July 16, 1984
L-84-177

Re: Turkey Point Units 3 and 4
Docket Nos. 50-250 and 50-251
Generic Letter 83-28
Item 4.3 - Shunt Trip

TURKEY POINT UNITS 3 & 4
CONCEPTUAL DESIGN FOR AUTOMATIC SHUNT TRIP
OF REACTOR TRIP BREAKERS AND BREAKER RESPONSE TIME TESTING

BECHTEL GAITHERSBURG, MARYLAND			
FLORIDA POWER & LIGHT COMPANY TURKEY POINT NUCLEAR UNITS UNIT NO. 3 1970-760 MW. INSTALLATION UNIT NO. 4 1971-760 MW. INSTALLATION			
REACTOR TRIP SWITCHGEAR SHUNT TRIP MODIFICATIONS			
DATE	DRAWING NO.		
E-4-B4			
FIGURE 1		FILE NUMBER: 8407230072-01

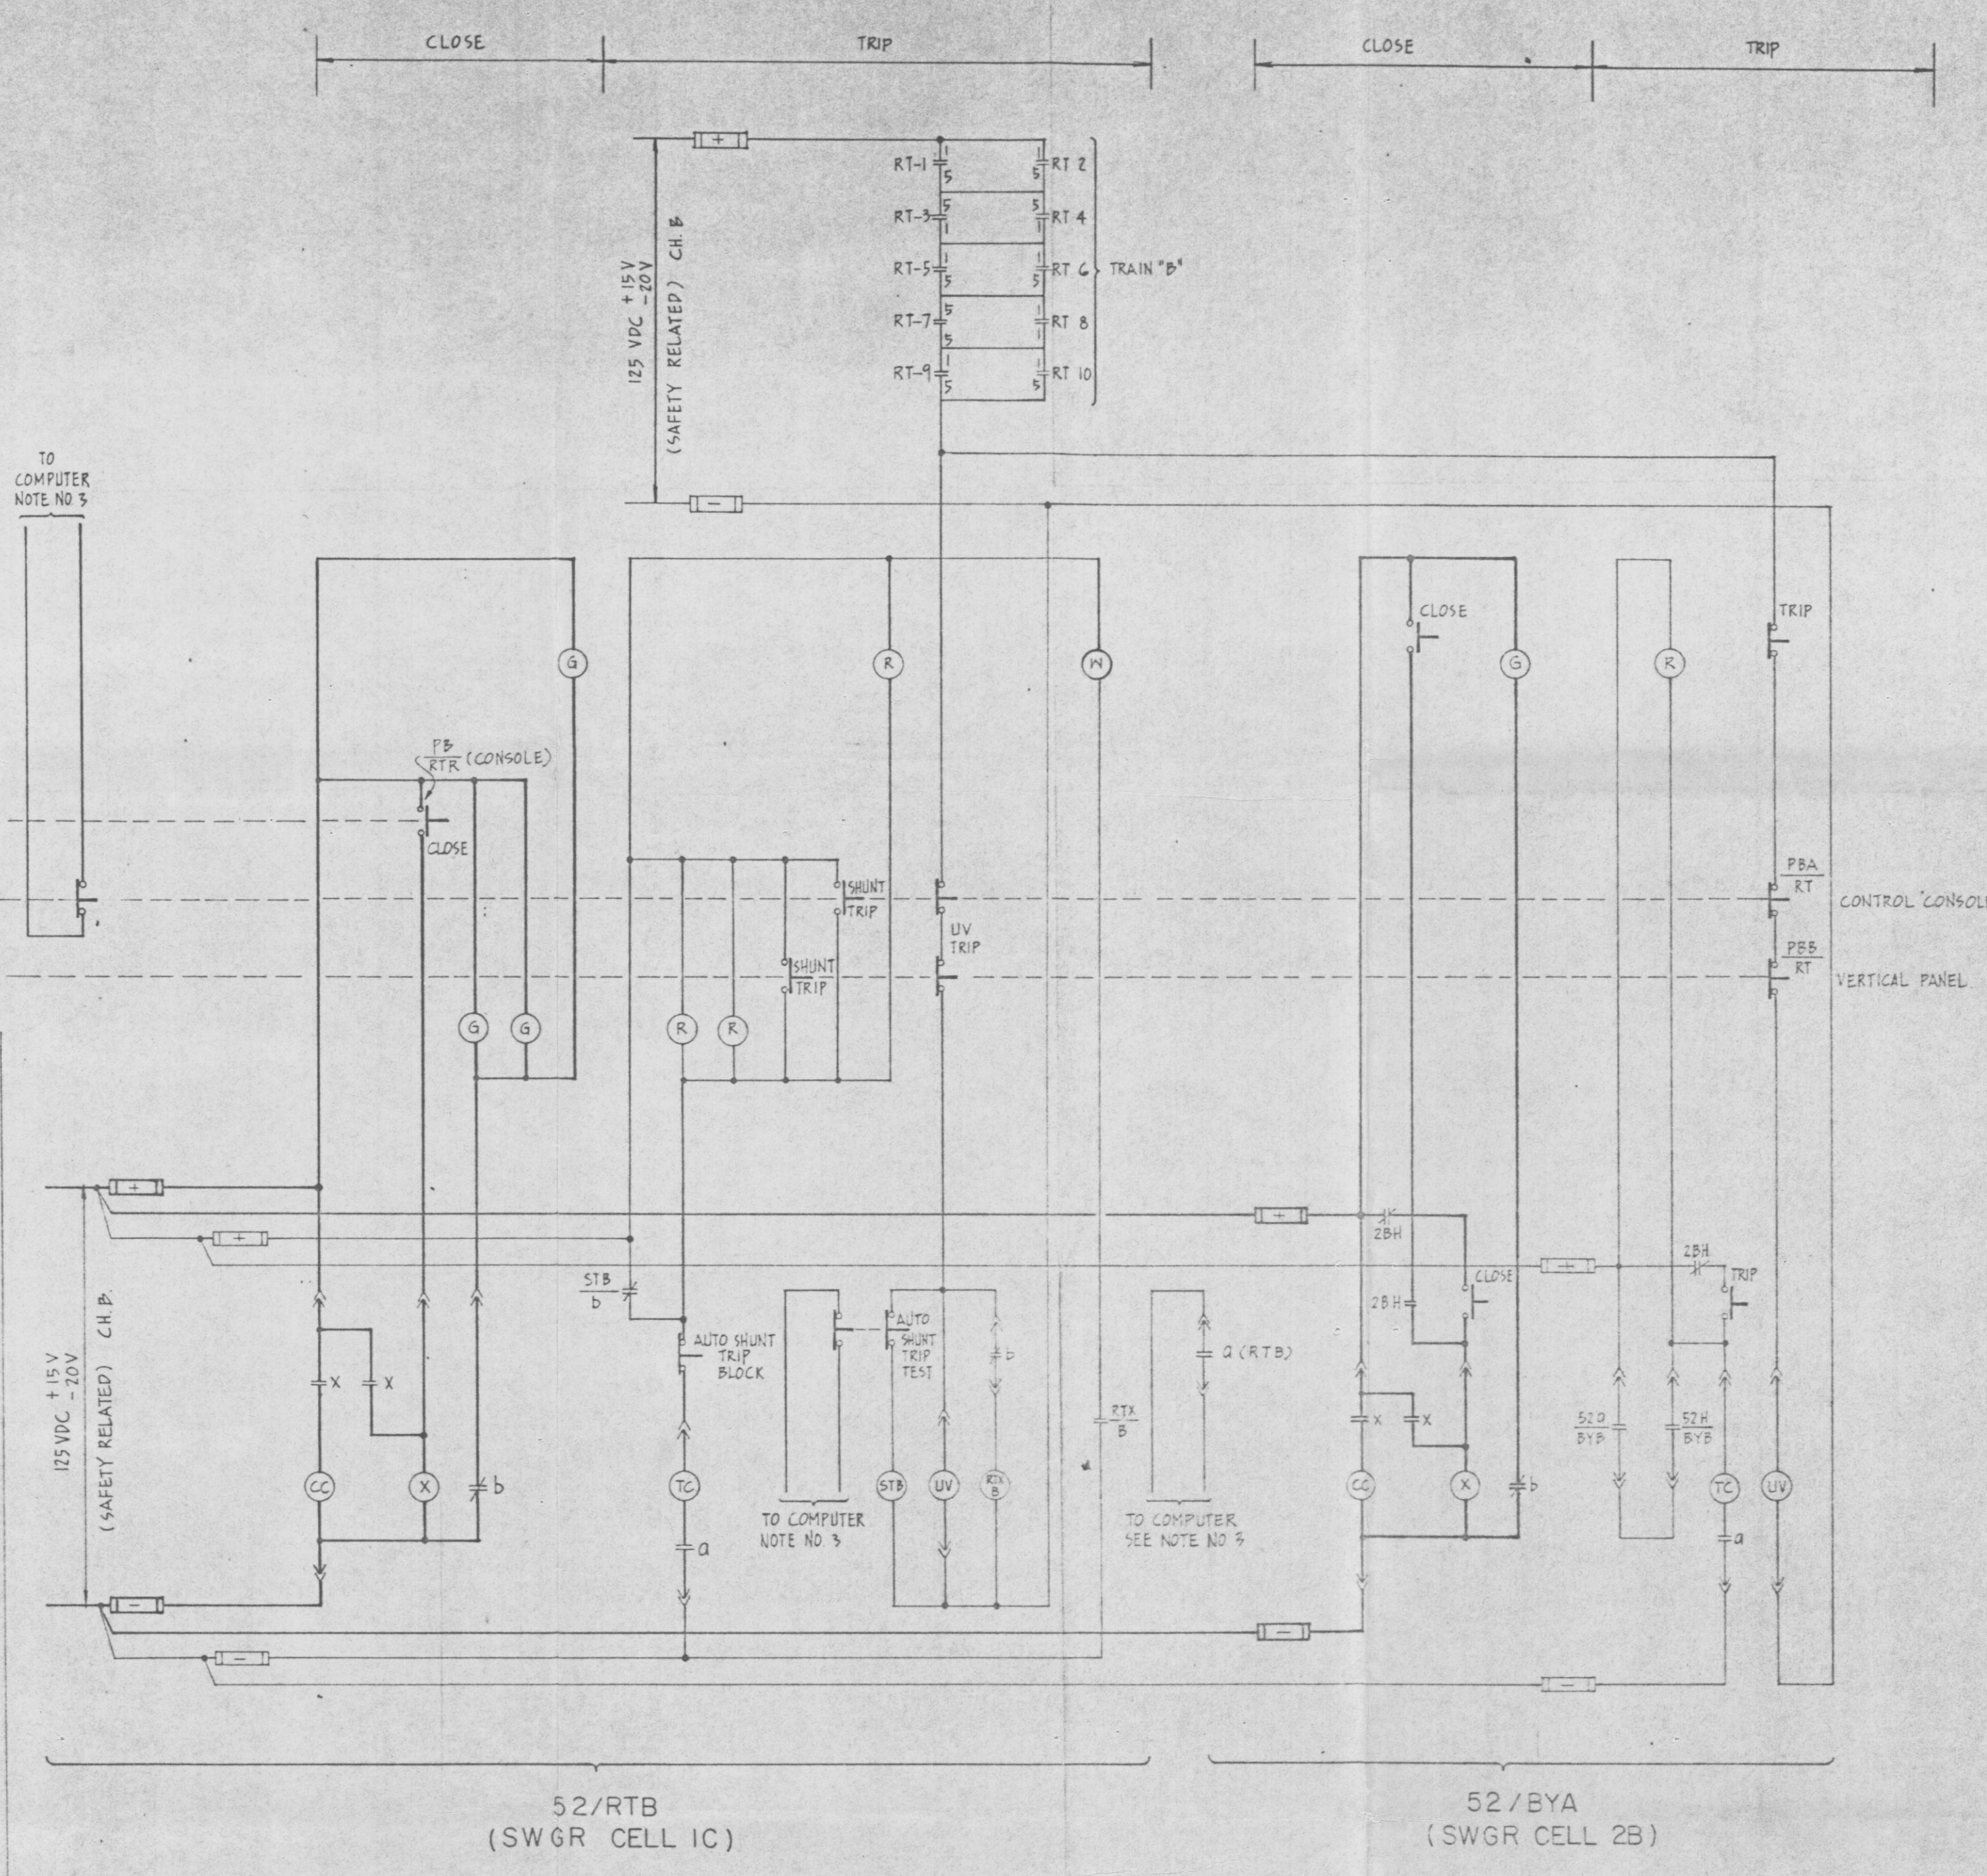
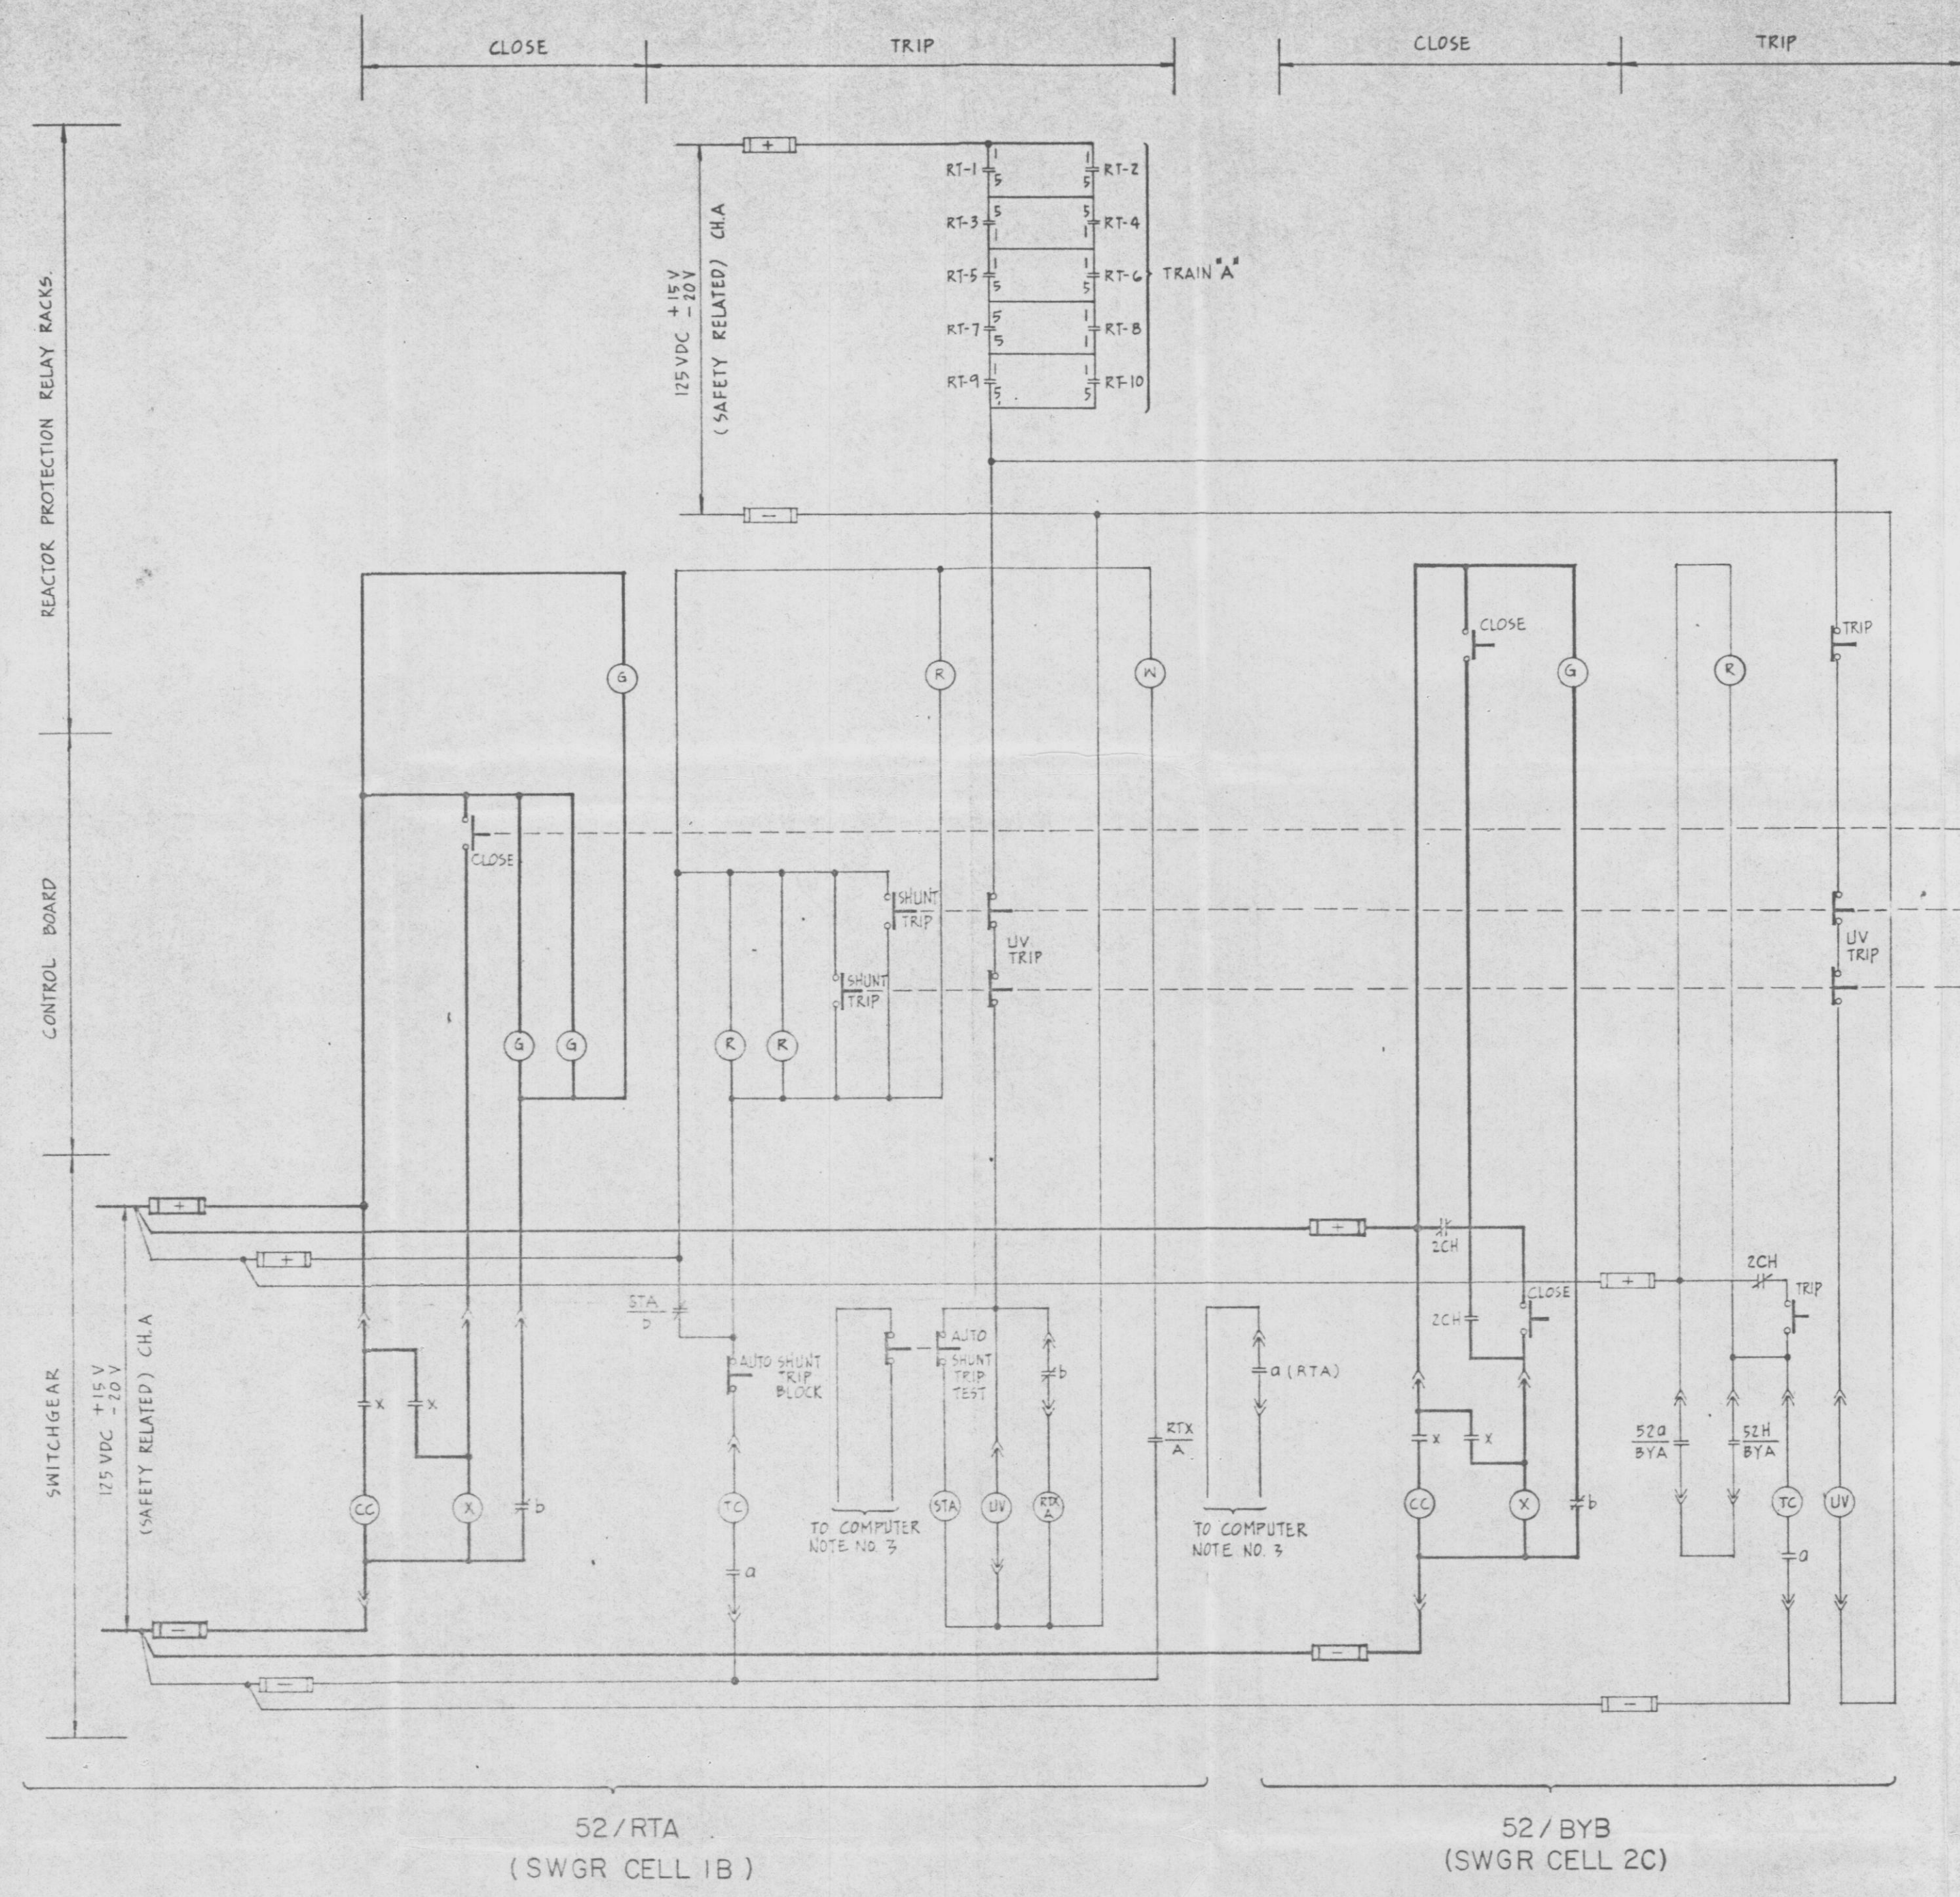
"Provide the electrical schematic/elementary diagrams for the reactor trip and bypass breakers showing the undervoltage and shunt trip coil actuation circuits as well as the breaker control (e.g., closing) circuits, and circuits providing breaker status information/alarms to the Control Room."

"Verify that the response time of the Automatic Shunt Trip feature will be tested periodically and shown to be less than or equal to that assumed in the FSAR analyses or that specified in the technical specifications."

Figure 1 shows the modifications for both breakers 52/RTA and 52/RTB. A control relay (STA or STB) and two test pushbuttons are mounted in the RTS and wired to the existing UV trip and shunt trip circuits. The relay (STA or STB) is energized from the Reactor Protection System logic train (A or B) voltage to the UV trip coil. When the voltage is removed by an automatic reactor trip signal, the relay (STA or STB) will be de-energized and its "b" contact will close to energize the shunt trip coil of the breaker. Thus the mechanical linkages of both the UV and shunt trip devices of the breaker will be actuated. Two pushbuttons (test & block) are used during testing to individually confirm the operability of the UV and the shunt trip mechanisms.

Attached Figure 1 for Turkey Point Units 3 and 4 shows the reactor trip and bypass breakers with associated closing and tripping circuits as well as the breaker status information in the Control Room.

Modified Operating Procedure 1004.2, as discussed in item 4, provides for independent verification of the reactor trip breaker operability with UV trip and automatic shunt trip. Figure 1 shows the contact inputs to a computer to check the circuit breaker opening response time. The reactor trip breaker response can be checked as follows:
